Work Order ID 114348

Item Name: Floor Provisions - Energy Attenuating Seat Compatible

DART SERVICE INSTRUCTION
TO AMEND INSTALLATION INSTRUCTIONS IIN-D350-689 REV. B
AND INSTRUCTIONS FOR CONTINUED AIRWORTHINESS ICA-D350-689 REV. 1

REF. TCCA STC: SH02-33
REF. FAA STC: SR01620NY
REF. EASA STC: EASA.IM.R.S.01453
REF. TCA STC: 2005S03-09

FIGURE 1: UPDATES TO CROSS SECTIONS F-F AND M-M

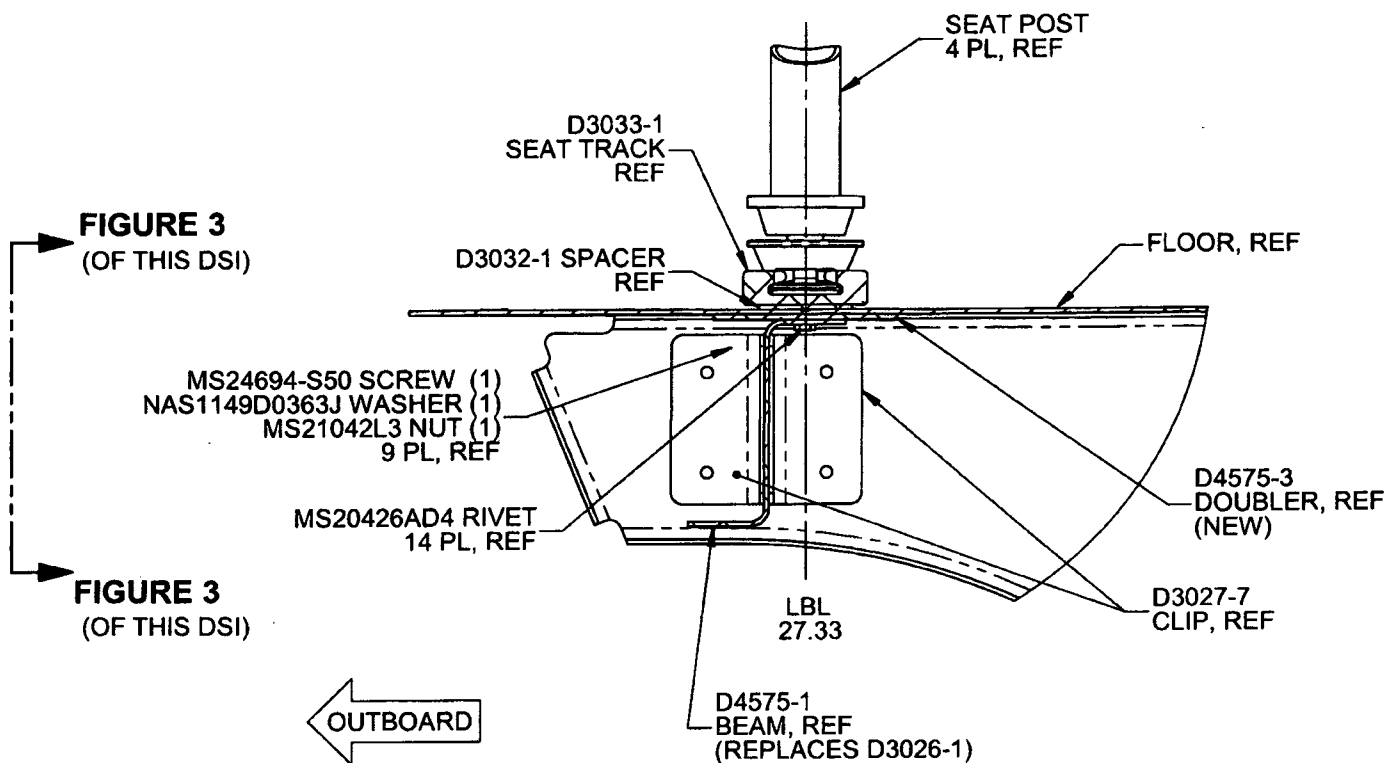
For D350-689-011/-013 at CHG 006/005 and later and D350-689-021/-023 Kits at CHG 005/004 and later, the D3026-1 Channel has been replaced with the D4575-1 Beam and D4575-3 Doubler and the D3234-3 Doubler has been removed. Consequently, the installation instructions for D350-689-011/-013 at CHG 006/005 and D350-689-021/-023 at CHG 005/004 are updated per Section 2.0 of this Service Instruction. The parts list update is shown in Section 4.0 of this Service Instruction. There is a negligible change to the weight and balance.

If there is an existing stringer at LBL 27.33, it will need to be removed from that location. Locate D4575-1 Beam, D4575-3 Doubler, and D3032-1 Spacer as shown in Figure 1 of this Service Instruction. Transfer drill existing holes from the aircraft floor to the D4575-1 Beam, D4575-3 Doubler, and D3032-1 Spacer. Ensure 1.0" to 1.5" rivet pitch and add additional holes if required. If there is no existing stringer, locate D4575-1 Beam, D4575-3 Doubler, and D3032-1 Spacer as shown in Figure 1 of this Service Instruction and drill Ø0.128" holes on a 1.0" to 1.5" pitch.

If there is an existing stringer at LBL 27.33, it will need to be removed from that location. Locate D4575-1 Beam and D4575-3 Doubler as shown in Figure 2 of this Service Instruction. Transfer drill existing holes from the aircraft floor to the D4575-1 Beam and D4575-3 Doubler. Ensure 1.0" to 1.5" rivet pitch and add additional holes if required. If there is no existing stringer, locate D4575-1 Beam and D4575-3 Doubler as shown in Figure 1 of this Service Instruction and drill Ø0.128" holes on a 1.0" to 1.5" pitch.

FIGURE 3: RELIEFS ON D4575-1/-3
(ONLY D4575-1/-3 SHOWN FOR CLARITY)
VIEW LOOKING INBOARD

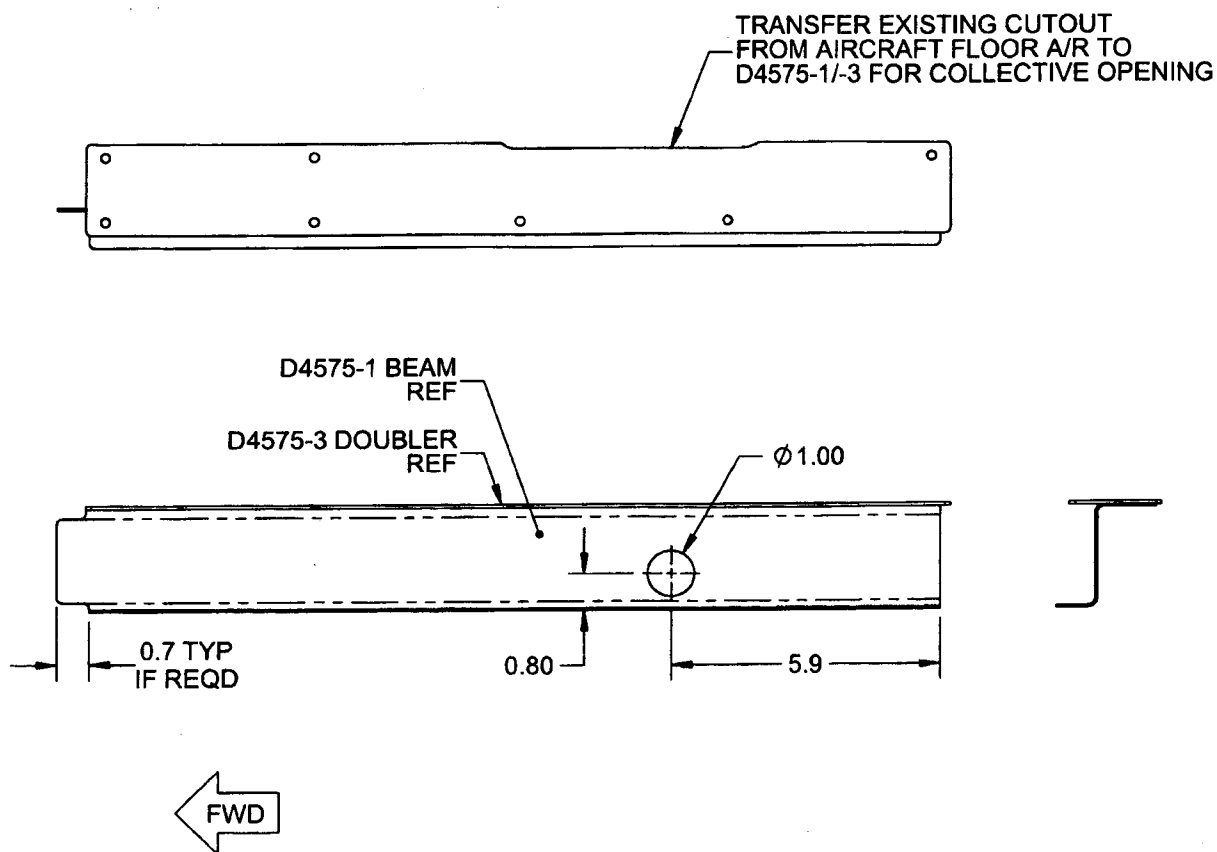
Note: Drill a Ø1.00" (Ø25.4 mm) hole in the D4575-1 Beam to clear extension tube of collective and cutout as required for clearance of collective opening and fwd bulkhead as shown in Figure 3 of this Service Instruction.

Note: Drill a Ø1.00" (Ø25.4 mm) hole in the D4575-1 Beam to clear extension tube of collective and cutout as required for clearance of collective opening and fwd bulkhead as shown in Figure 3 of this Service Instruction.
